ADDENDUM No. 1
Bid Package #1: Construction Documents
Encompass Architects, p.c.

Canopy Row
700 N St., Lincoln, NE 68508
NGC Group

EA Project No.: 16-1100

DATE OF ISSUANCE: February 8, 2017

LOWER LEVEL FLOOR PLAN- BUILDING B
SCALE: 1/8" = 1'-0"

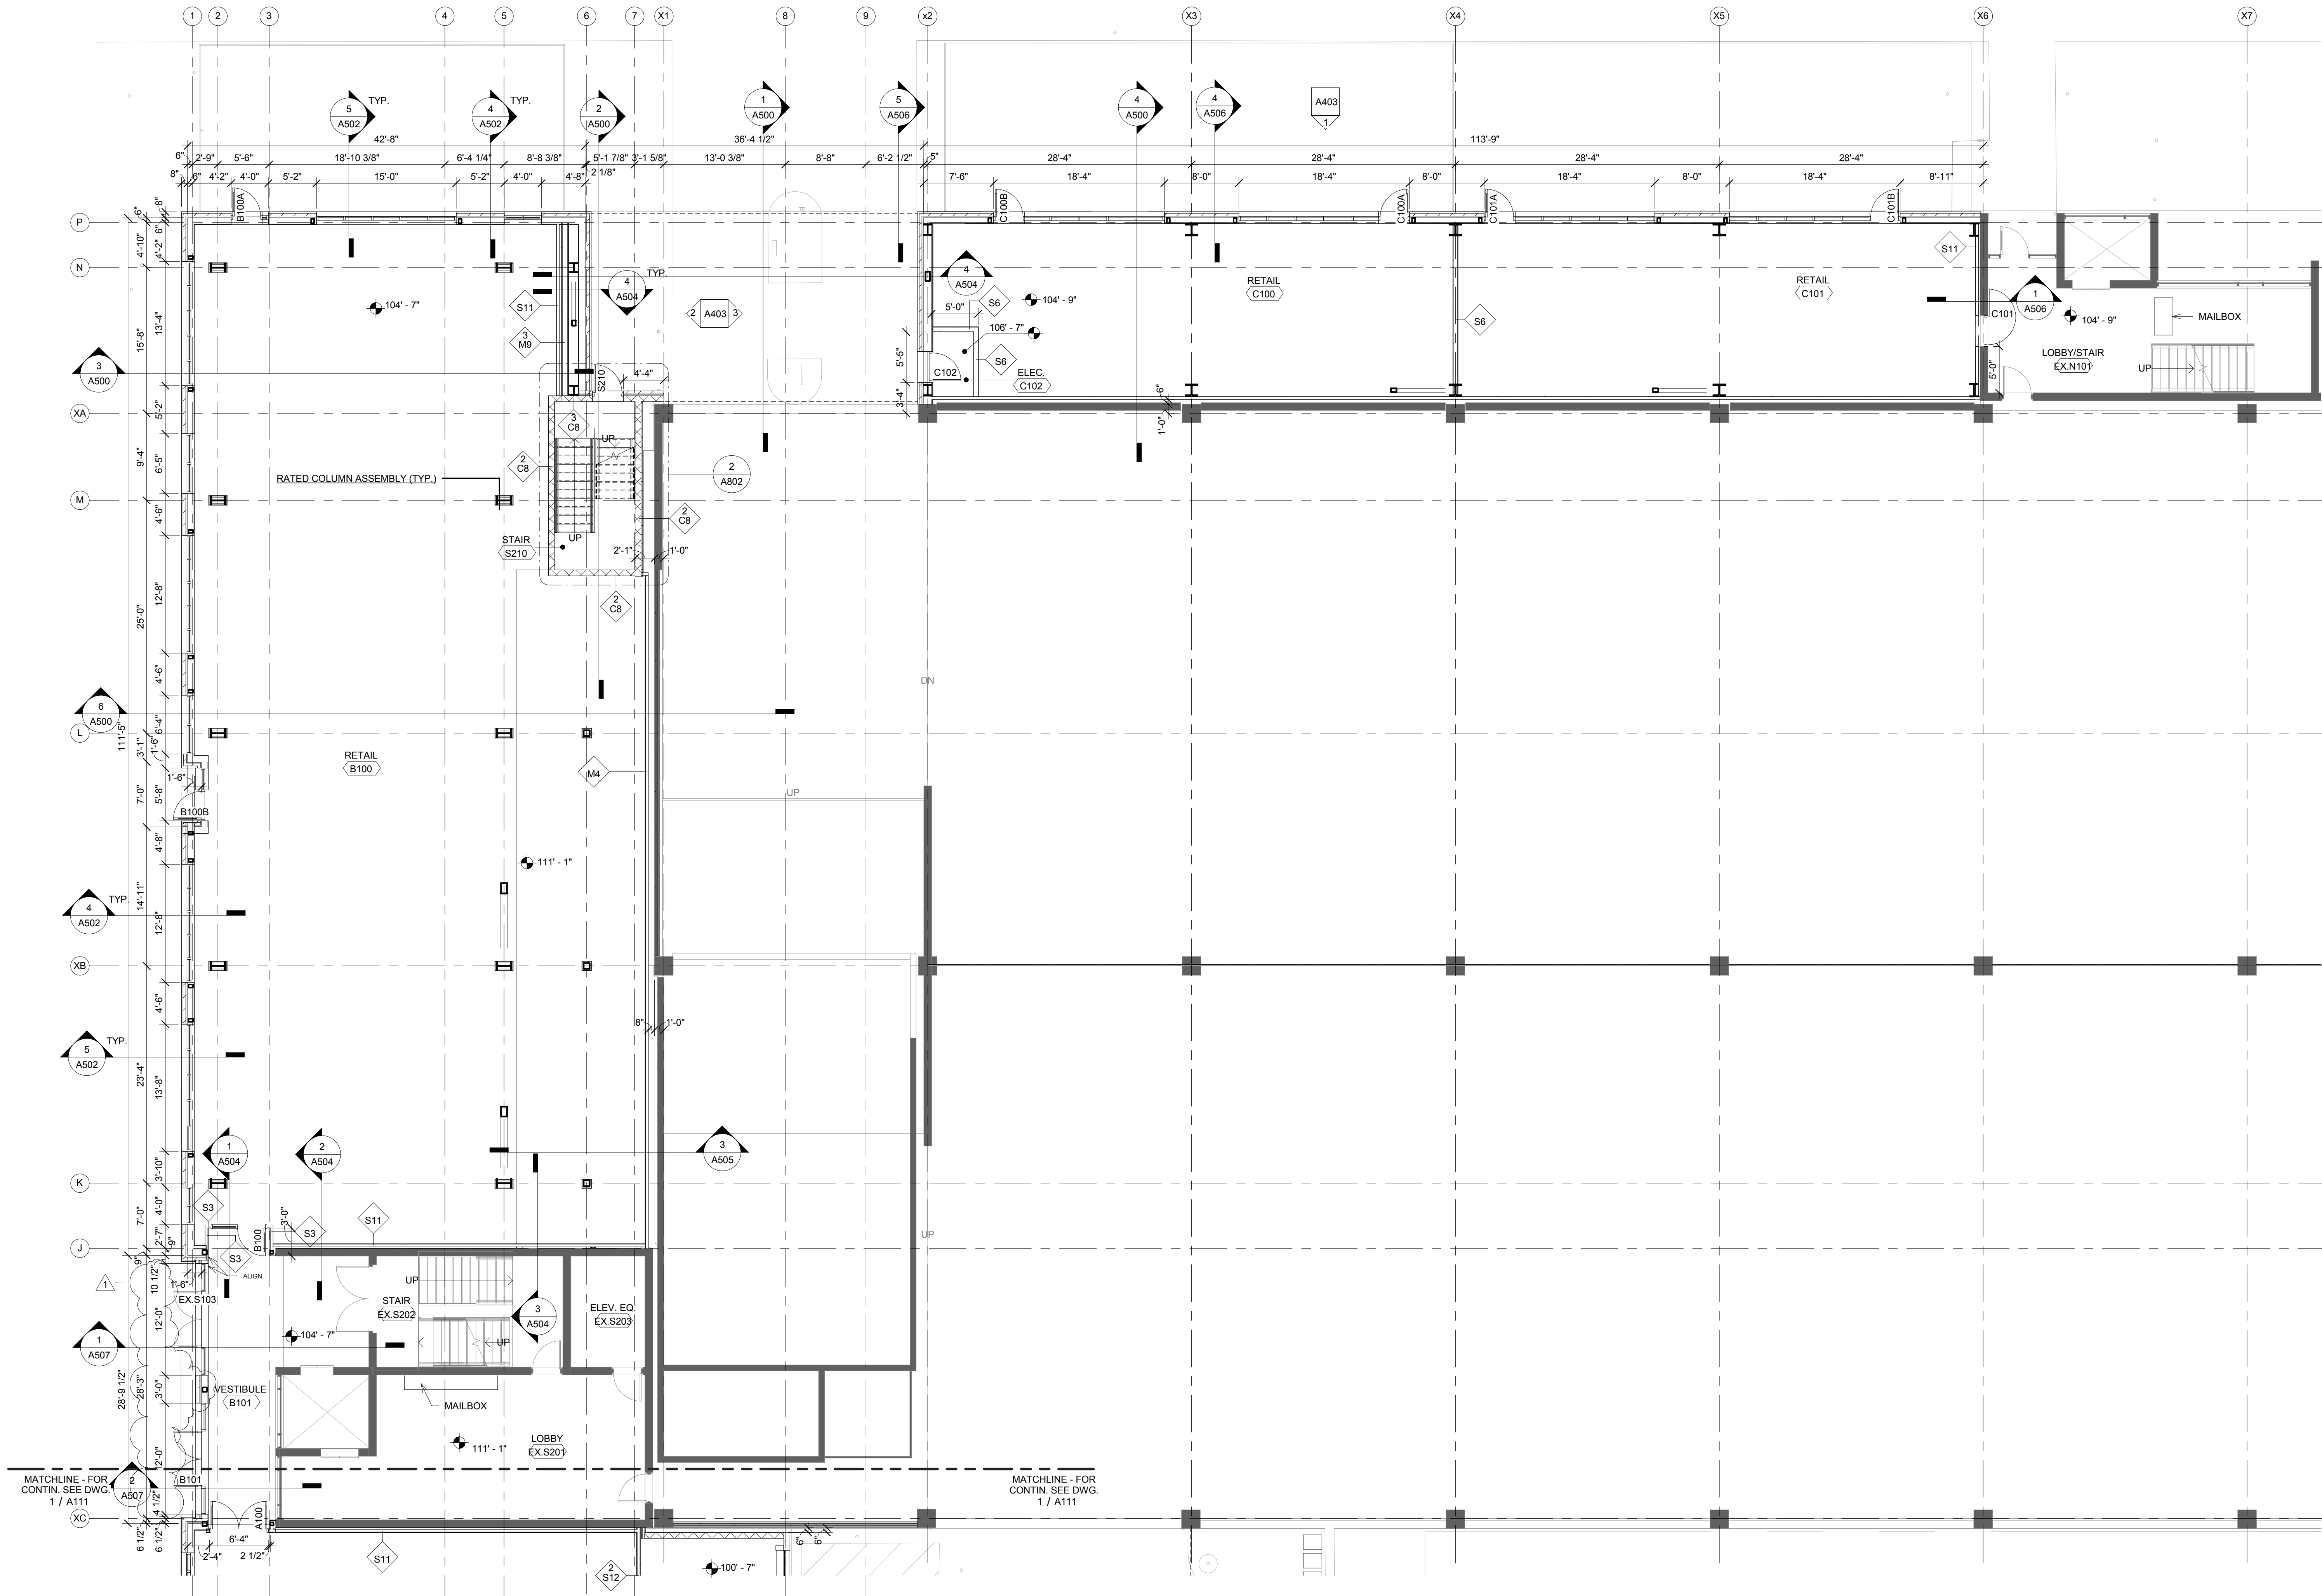
- Item AD-12. Sheet A102 – Lower Level Floor Plan- Building B
- a. View 1/A102, Replace (2) 8” CMU partitions with 12” CMU partitions as indicated on the attached sheet A102.

2
SECTION @ BUILDING A DRIVE BALCONY
SCALE: 1/4" = 1'-0"

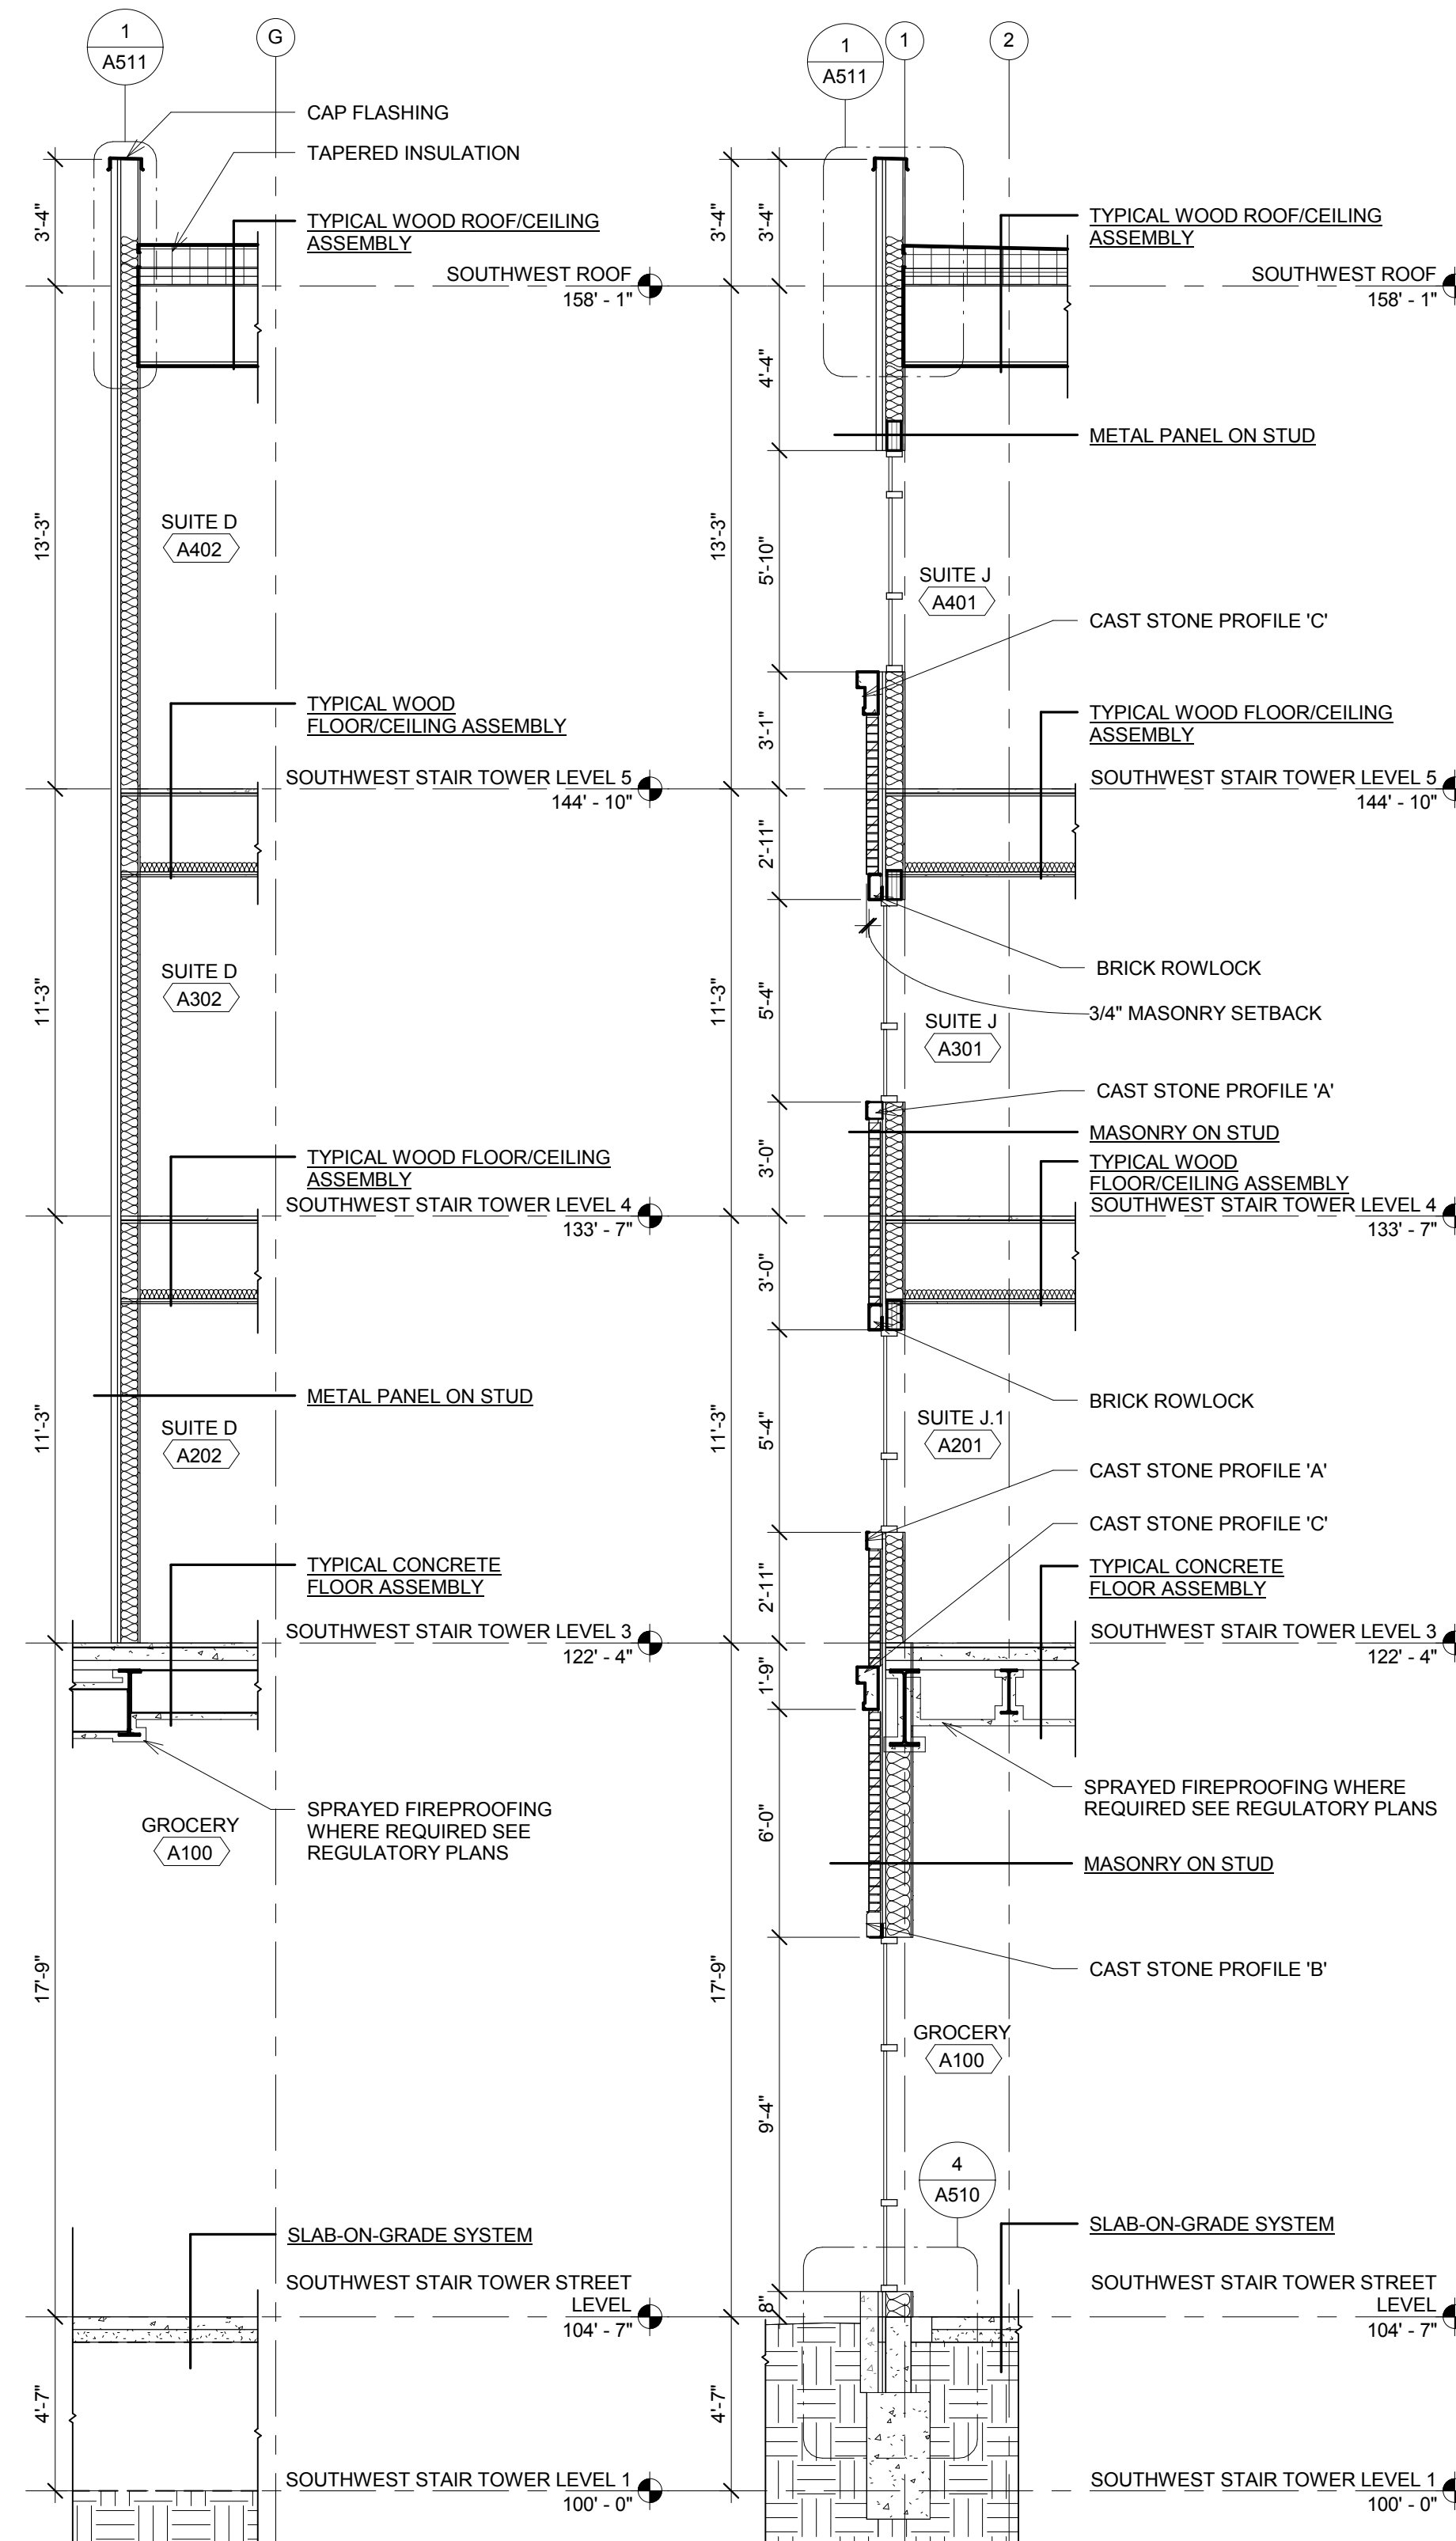
- a. View 2/A502 & 5/A502, Delete “Prefabricated steel guardrail”. Replace with “Prefabricated alum. guardrail by prefabricated balcony assembly manufacturer”.

3
A507 EXPANSION JOINTS- DOOR
SCALE: 1 1/2" = 1'-0"

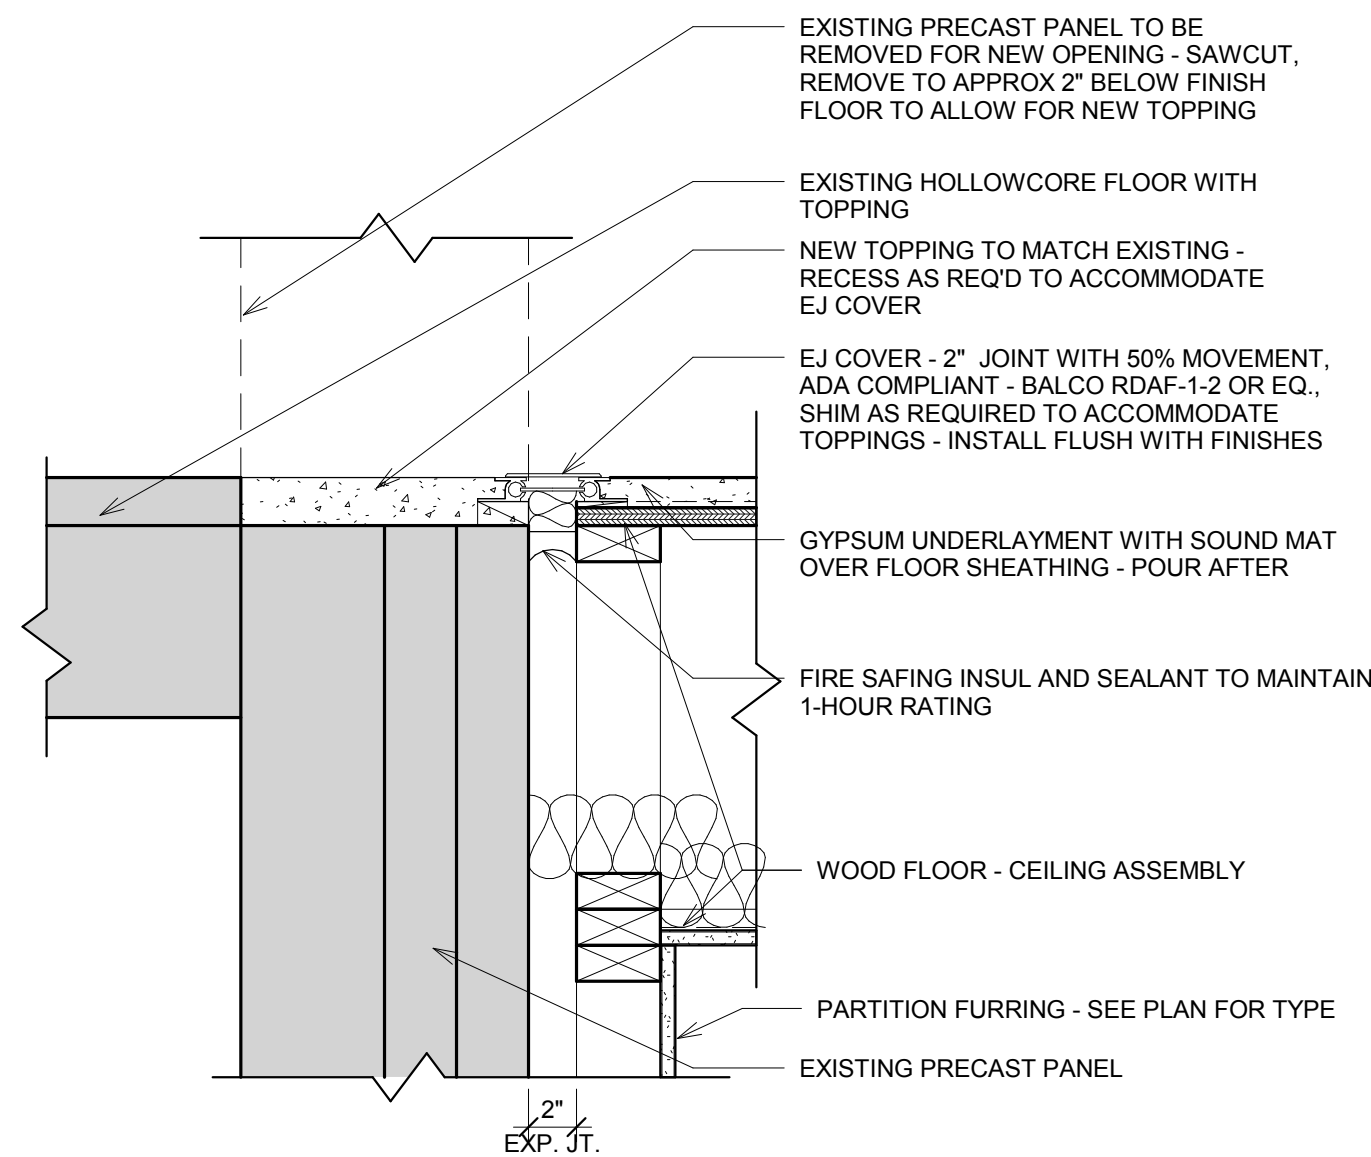
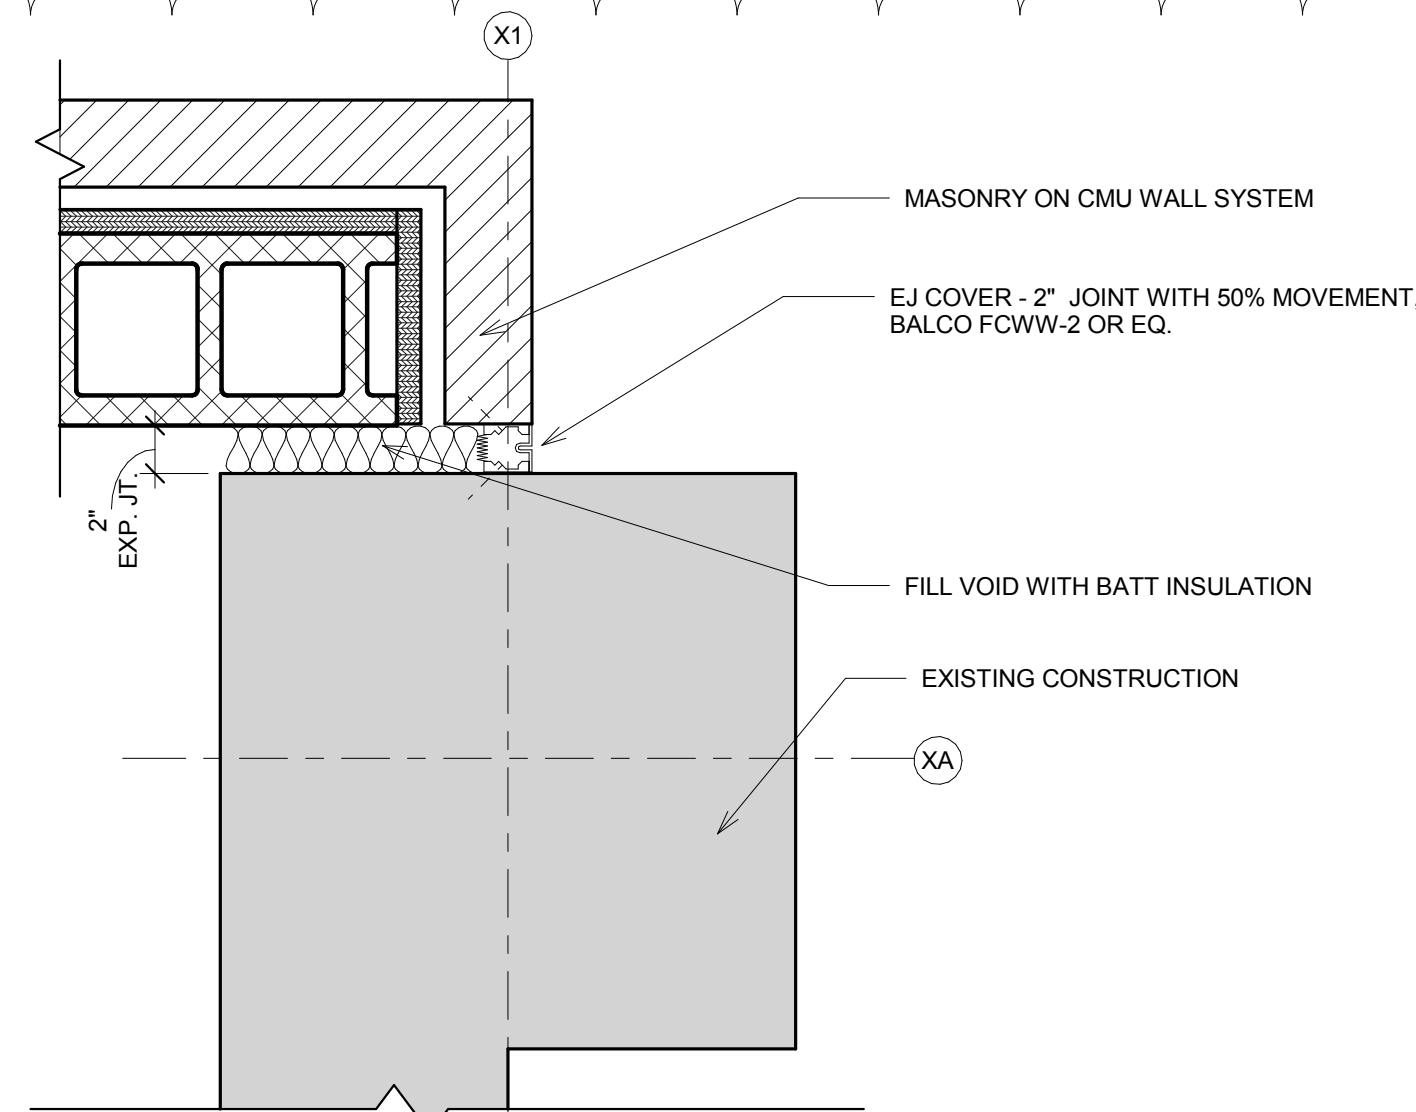
- Item AD-18. Sheet A507 – Wall Sections
- a. Add Detail 3/A507 Expansion Joints- Door and Detail 4/A507 Expansion Joints- Exterior
- Item AD-19. Sheet A512 – Details
